### APPEAL SUMMARY

<b>Appeal ID:</b> 31469	<b>Project Address:</b> 455 SW Hamilton Ct
<b>Hearing Date:</b> 4/12/23	<b>Appellant Name:</b> Cameron Klenski
<b>Case No.:</b> M-001	<b>Appellant Phone:</b> 208-519-4078
<b>Appeal Type:</b> Mechanical	<b>Plans Examiner/Inspector:</b> Sean Vanderjagt, Mechanical Engineer
<b>Project Type:</b> commercial	<b>Stories:</b> 7 <b>Occupancy:</b> R-1 <b>Construction Type:</b> I-B
<b>Building/Business Name:</b> Rivers Edge Hotel	<b>Fire Sprinklers:</b> Yes - All floors.
<b>Appeal Involves:</b> Alteration of an existing structure	<b>LUR or Permit Application No.:</b> 22-148268-CO
<b>Plan Submitted Option:</b> pdf [File 1] [File 2] [File 3]	<b>Proposed use:</b> Hotel (R1 occupancy)

### APPEAL INFORMATION SHEET

## M2.10

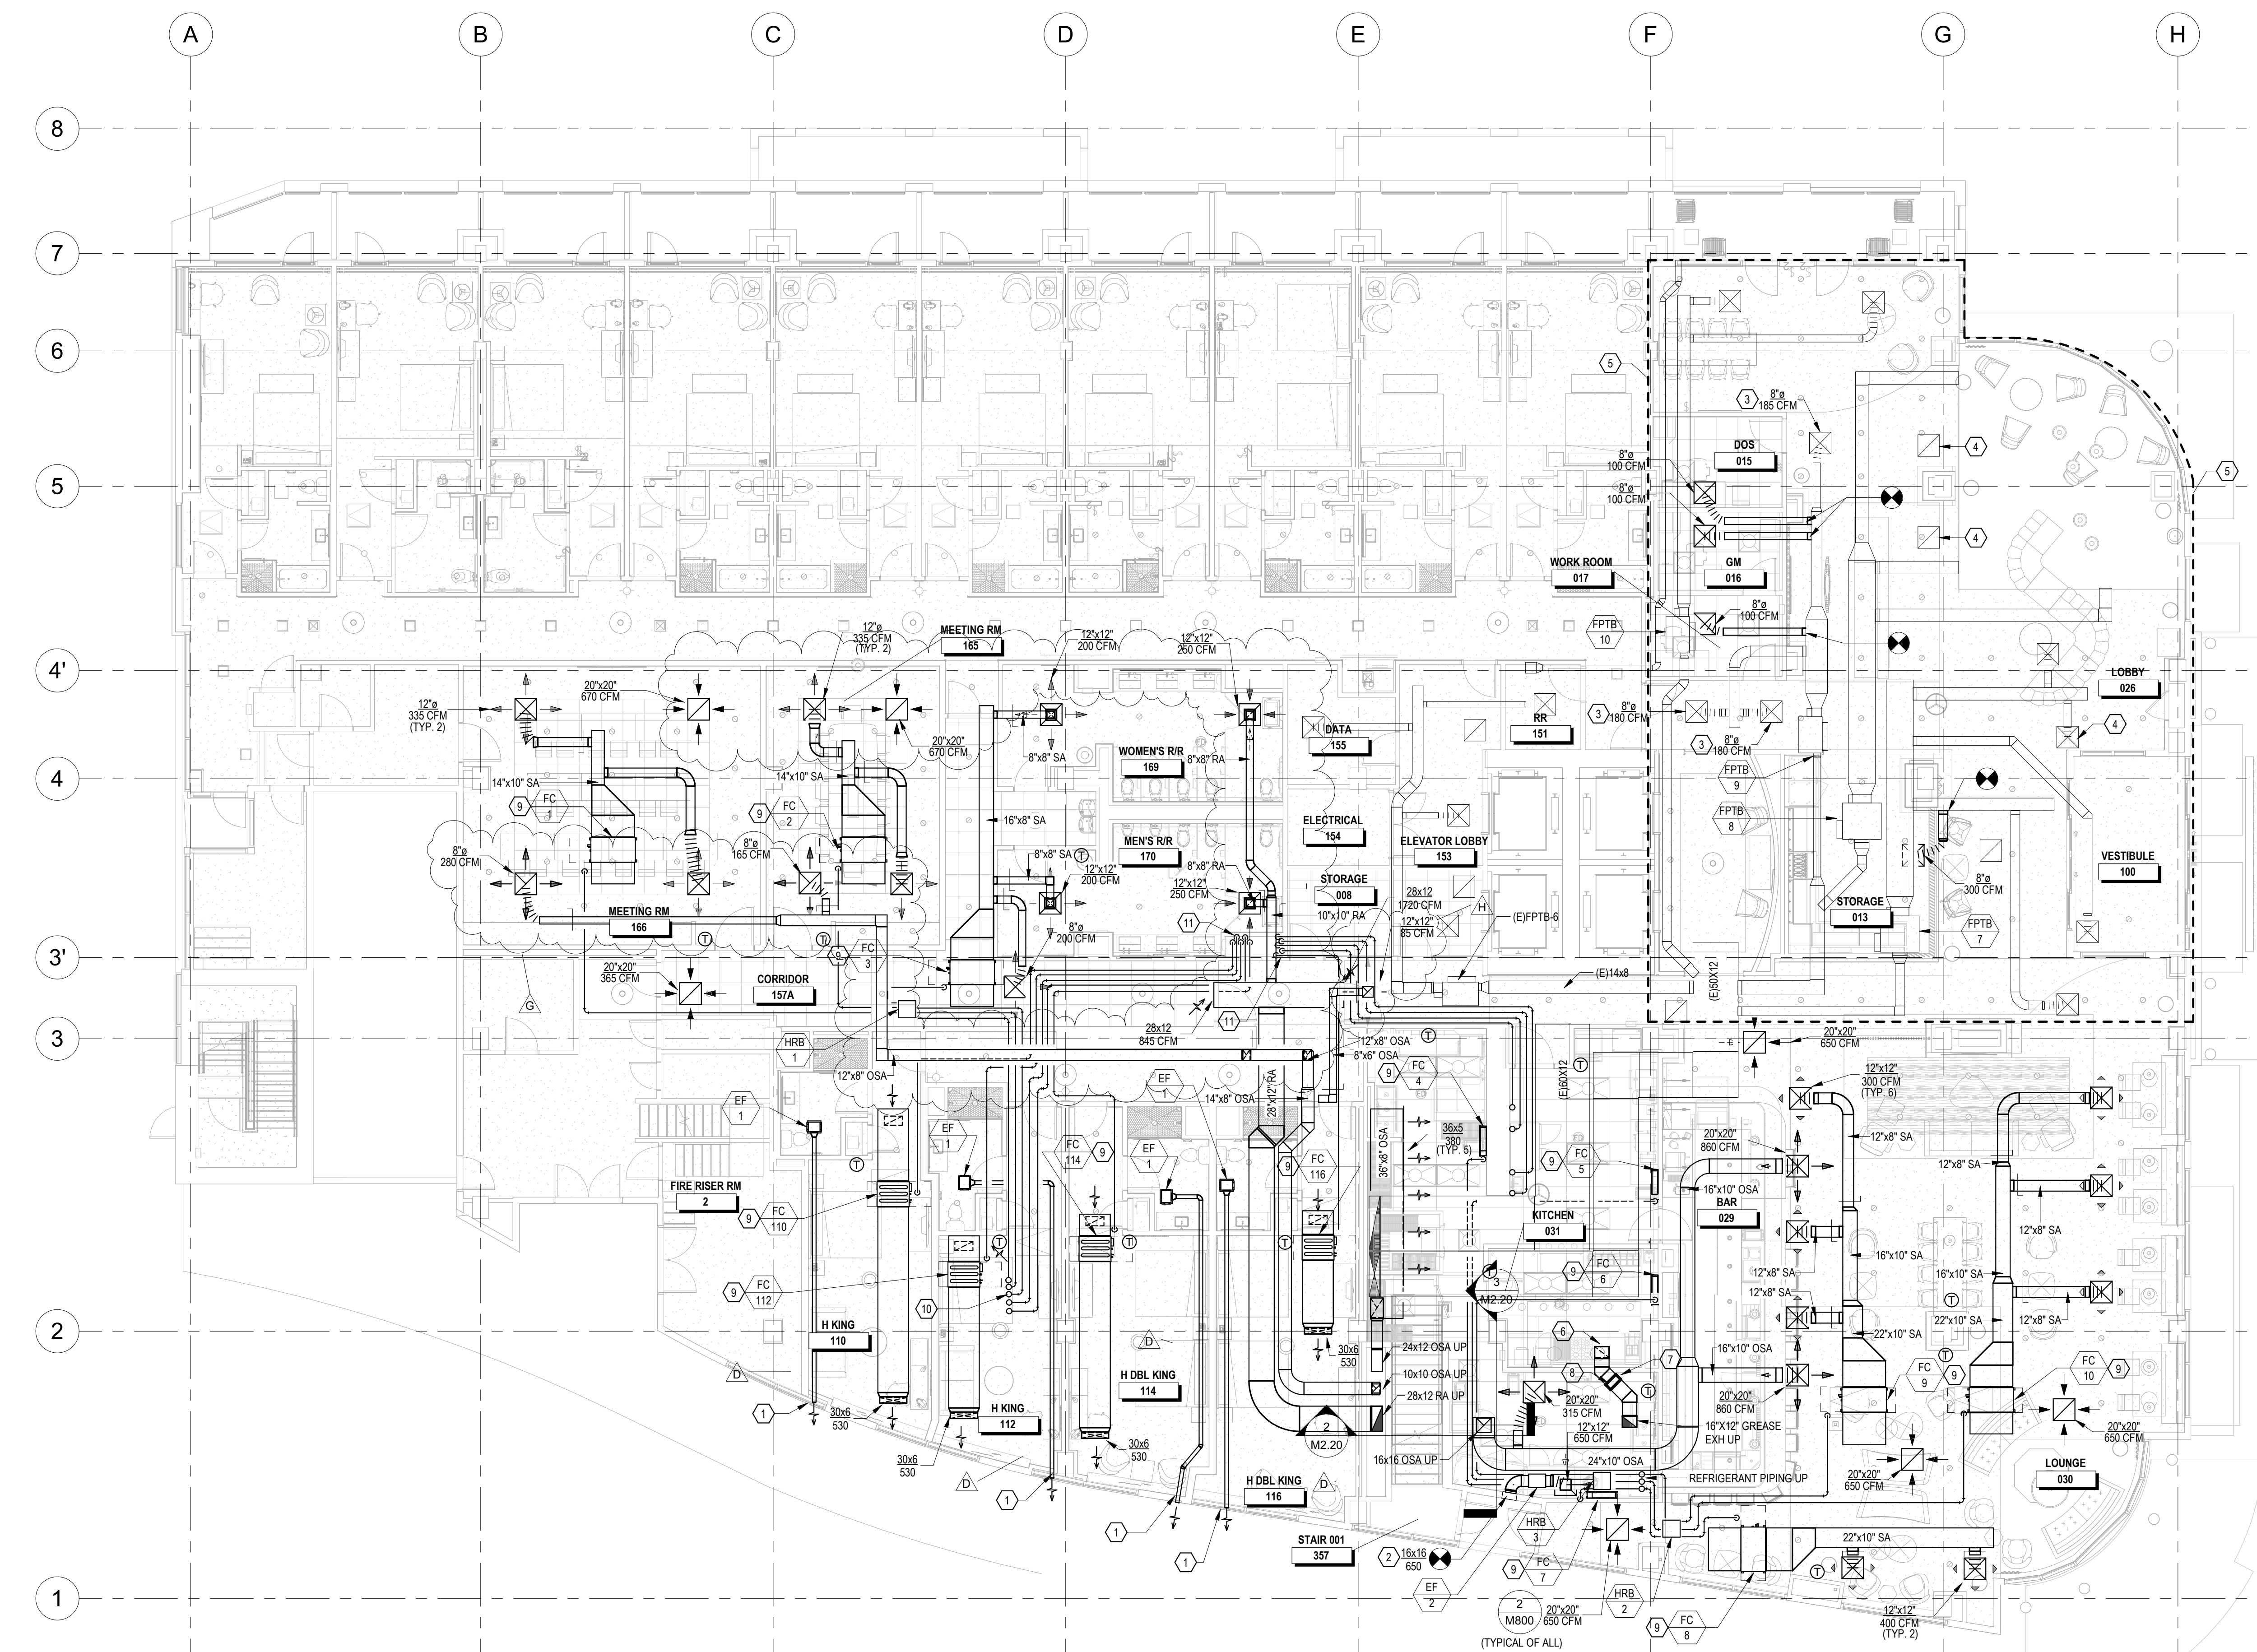
<b>Code Section</b>	OMSC 607.5.4 and OSSC 717.5.4.1
<b>Requires</b>	Corridor damper required at supply air register (from ERV) in corridor.
<b>Code Modification or Alternate Requested</b>	The intent of the appeal is to address an inspection notice for a fire/smoke damper required in a corridor.
<b>Proposed Design</b>	<p>The supply air diffuser is being removed from the rated corridor and placed adjacent to the rated corridor. The door between the spaces is on hold opens.</p> <p>Additionally, the ERV serving the space will be interlocked with the fire alarm system and shut down and close dampers upon detection of smoke in the building.</p>
<b>Reason for alternative</b>	The design is equivalent from health and fire protection stand point as it removes the diffuser from the corridor and does not allow the spreading of smoke through the HVAC unit.

**Omission of fire / smoke damper in corridor: Hold for additional information.**
